UNITED STATES PATENT AND TRADEMARK OFFICE

| APPLICATION NO. | FILING DATE | FIRST NAMED INVENTOR | ATTORNEY DOCKET NO. | CONFIRMATION NO. |
|--|-------------|--------------------------------|------------------------------------|------------------|
| 10/807,226 | 03/23/2004 | William Fredrick Tschirlig JR. | 4418-121 US | 3308 |

| Office Action Summary | Application No. 10/807,226 | Applicant(s) TSCHIRLIG, WILLIAM FREDRICK | |

DETAILED ACTION

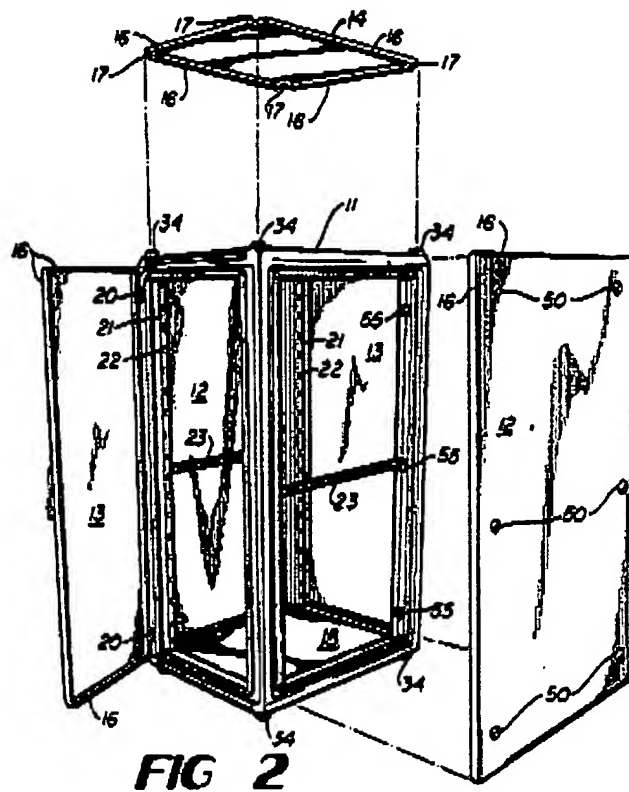
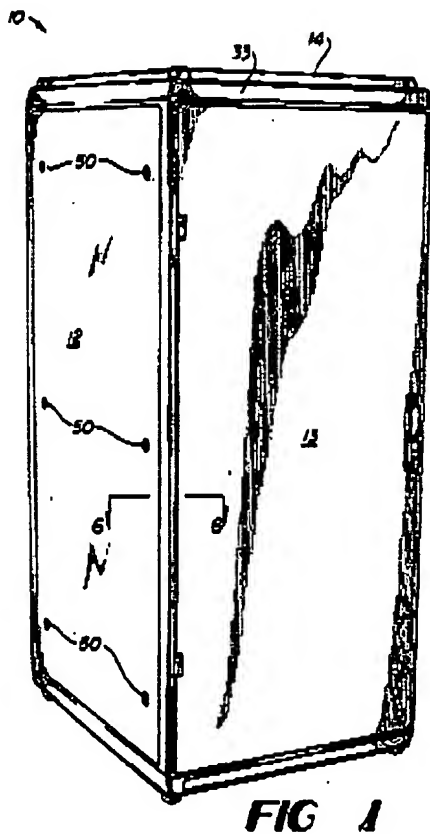
10. Claims 1, 4-6, 10 and 12-15 rejected under 35 U.S.C. 102(b) as being anticipated by McIlwraith (US Patent Number Re 34393). McIlwraith (Figures 1-6) discloses a cabinet capable of being mounted in a bathroom comprising: a cabinet body (10) capable of being mounted on a wall having an internal storage area (interior of 10) capable of receiving items and a cabinet body lip (31); the cabinet body comprising a top sidewall (14), a bottom sidewall (15), a hinge sidewall and a non-hinge sidewall

11. Regarding claim 4, McIlwraith discloses the corner structural elements are connected to the corresponding sidewall by fasteners (50 and 56, via elements 27 and 25).

14. Regarding claim 10, McIlwraith further discloses a plurality of corner caps (25) wherein the corner caps are attached to corresponding corner structural elements such that the corner cap is essentially flush with the cabinet body lip.

18. Regarding claim 15, McIlwraith further discloses the material is at least partially hollow (see Figure 5).

McIlwraith '393 Figures 1 and 2

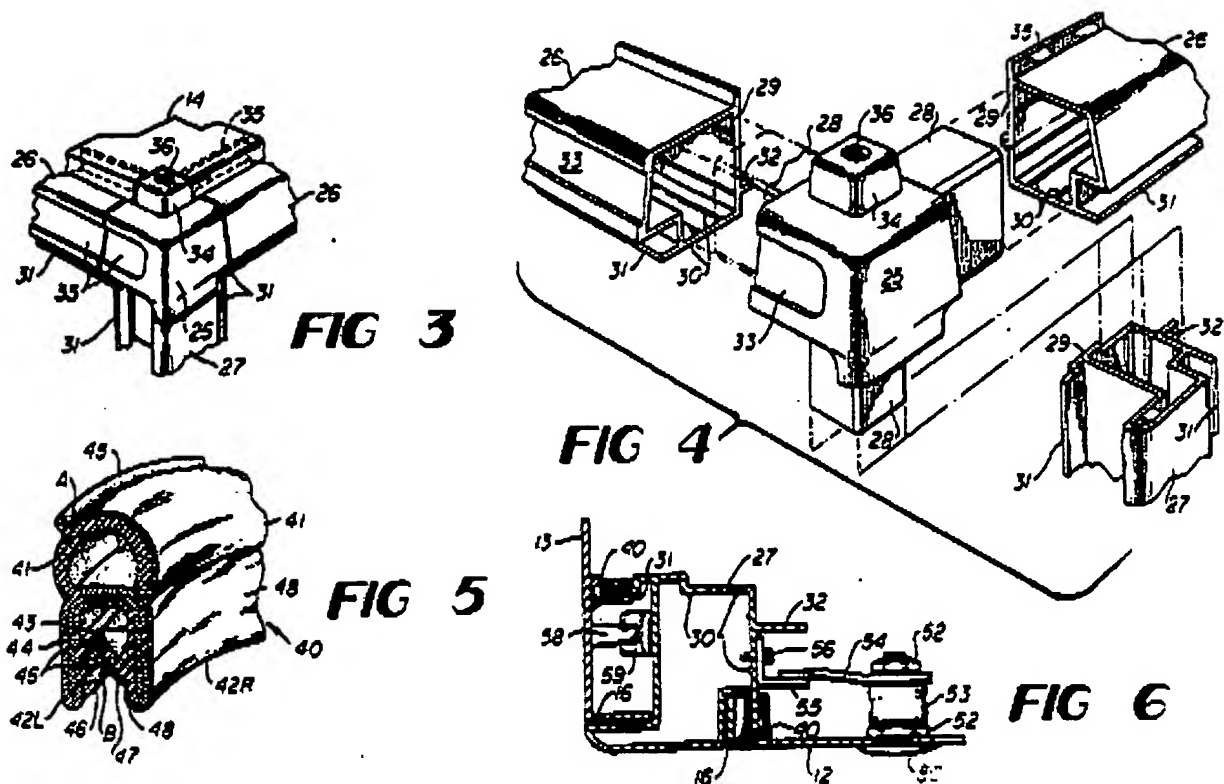
(both labeled 12), the top sidewall connected to the hinge sidewall by a first corner structural element, the top sidewall connected to the non-hinge sidewall by a second corner structural element; the bottom sidewall connected to the hinge sidewall by a third corner structural element, the bottom sidewall connected to the non-hinge sidewall by a fourth corner structural element (all of the corner structural elements are labeled 26); a cabinet door (13) pivotally mounted to said cabinet body; and a cabinet seal (40) coupled to the cabinet body lip; wherein the cabinet seal substantially covers the outer cabinet body lip.

Katz '627 Figure 1

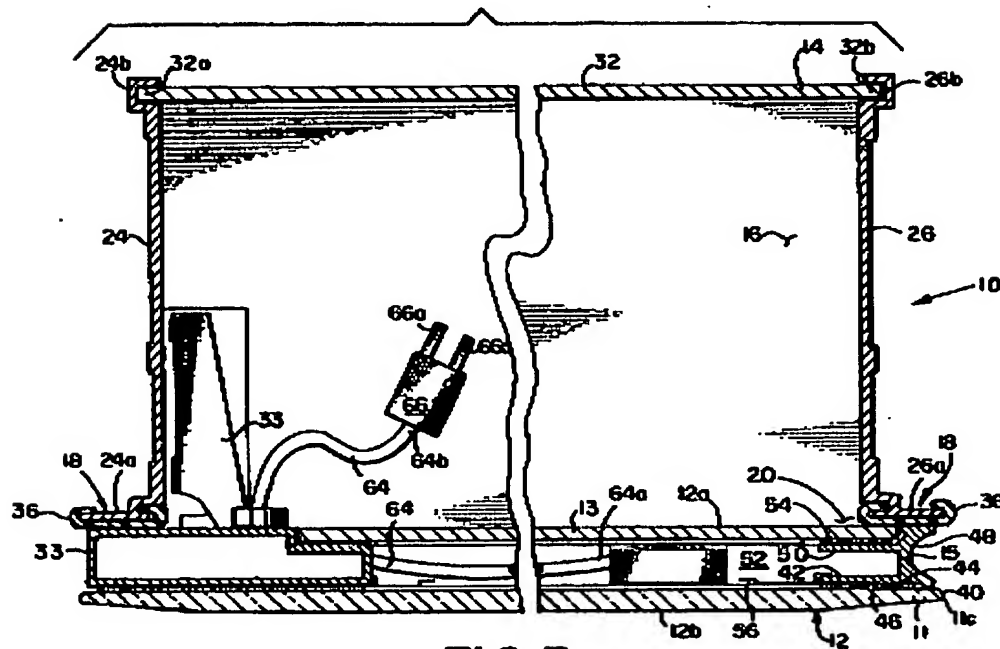
23. Regarding claims 1, 8, 16, and 17, Katz (Figures 1 and 3) discloses a cabinet capable of being mounted in a bathroom comprising: a cabinet body (14) capable of being mounted on a wall having an internal storage area (16) capable of receiving items and a cabinet body lip (formed by 24a, 26a, and the corresponding top and bottom flanges not shown but mentioned in column 4 lines 30-34); the cabinet body comprising a top sidewall (30), a bottom sidewall (28), a hinge sidewall (24) and a non-hinge sidewall (26) each having a channel (24b, 26b, and channels in the top and bottom sidewalls not shown but mentioned in column 4 lines 28-30); a cabinet door (12) pivotally mounted to said cabinet body; a cabinet seal (36) coupled to the cabinet body lip; wherein the cabinet seal substantially covers the outer cabinet body lip; and a back support (32) held by the sidewall channels. [Note that the back support of claim 8 is viewed as being a positively recited claim limitation despite being introduced in
